INDESIT company

Model type:
IDL75EU

Commercial code:
F030661

Notices

N1045072FIG1

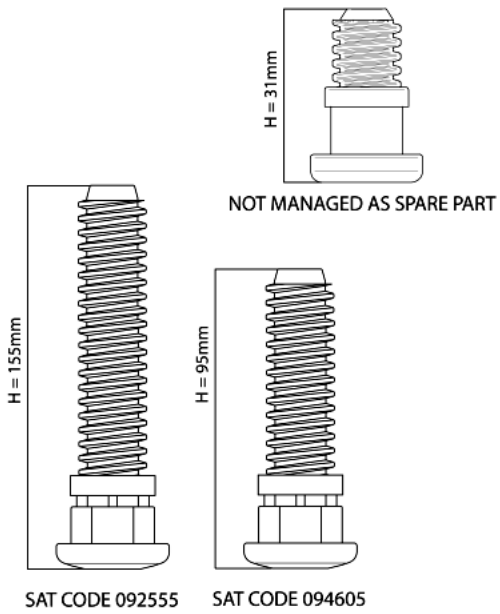
N1045072: Introduction of fixed rear foot H=31mm on free-standing models.

From serial no. 40218.0001, free-standing dishwashers affected by this modification have been equipped with new fixed rear feet (H=31mm).
The new foot replaces the adjustable one (H=155mm) Service code 092555; on the EVO3 range with TurboDry the new foot replaces the adjustable foot (H=95mm) Service code 094605.
The Spare Part Warehouse will continue to manage only 155mm and 95mm adjustable feet as they are interchangeable with the fixed 31mm foot.
The three feet are shown in illustration N1045072FIG1.

N1045083FIG1

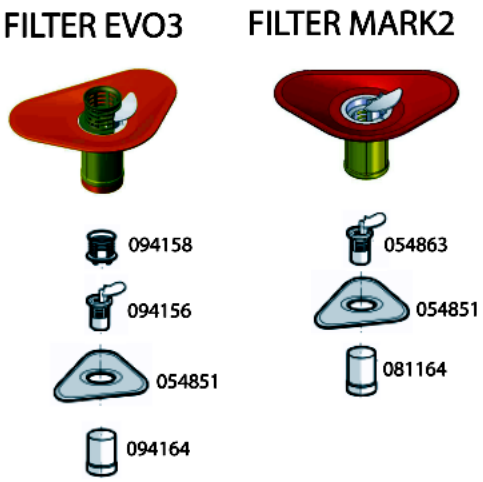
n1045083: Modification of filters on EVO3 60 cm dishwashers

All dishwasher models affected by this modification have been equipped with the items listed below, in order to solve the drain pump clooging problem.

Introduction of:
Cylindrical plastic filter code 081164
Central filter code 054863

Elimination of:
Cylindrical plastic filter code 094164
Central filter code 094156
Central filter grid code 094158

The modification has been introduced progressively, starting from serial no. 40516.0001.

n1045085: Introduction of new litre counter turbine integrated on air-break.

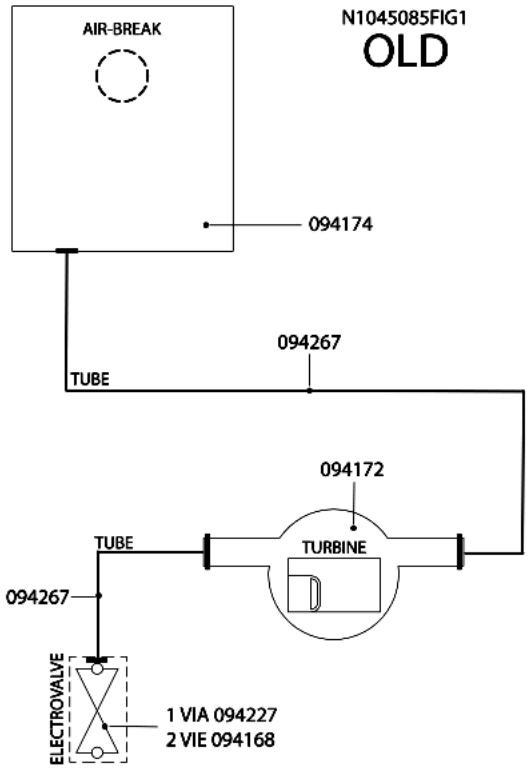
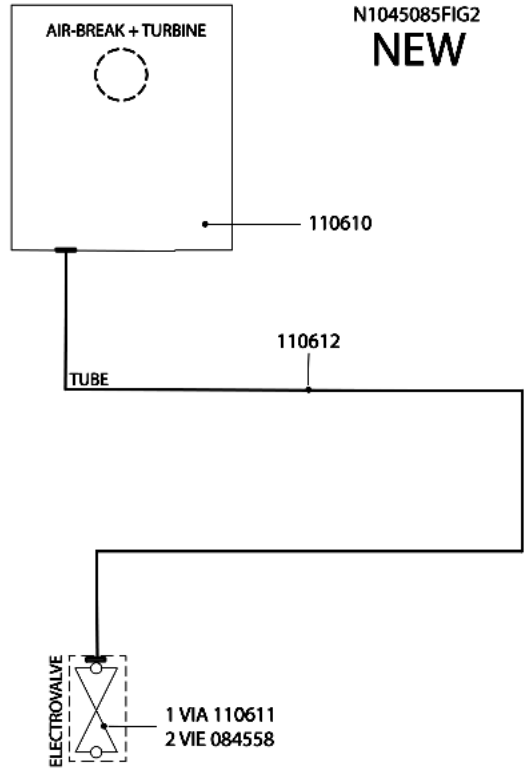
All dishwashers affected by this note have been equipped with a new litre counter turbine on the air-break.
Picture N1045085FIG1 illustrates the premodification structure, picture N1045085FIG2 the new structure.

AIR-BREAK:
new 110610;
premodification 094174;
the new item features a new integrated litre counter turbine and its water supply hose has a smaller diameter.

LITRE COUNTER TURBINE code 094172 has been eliminated.

SOLENOID VALVES:
new:
1-WAY code 110611;
2-WAY code 084558(Rohs 143737);
premodification:
1-WAY code 094227;
2-WAY code 094168;
the new solenoid valves have a smaller diameter drain hose fitting.

HOSES:
new solenoid valve hose/air-break code 110612;
premodification turbine hose/air-break code 094267;
premodification solenoid valve hose/air-break code 094267;
the new hose has a smaller internal diameter.

WIRING:
the litre counter turbine connecting cable is longer, but since the connector is the same, the new item can be used in place of the premodification one.
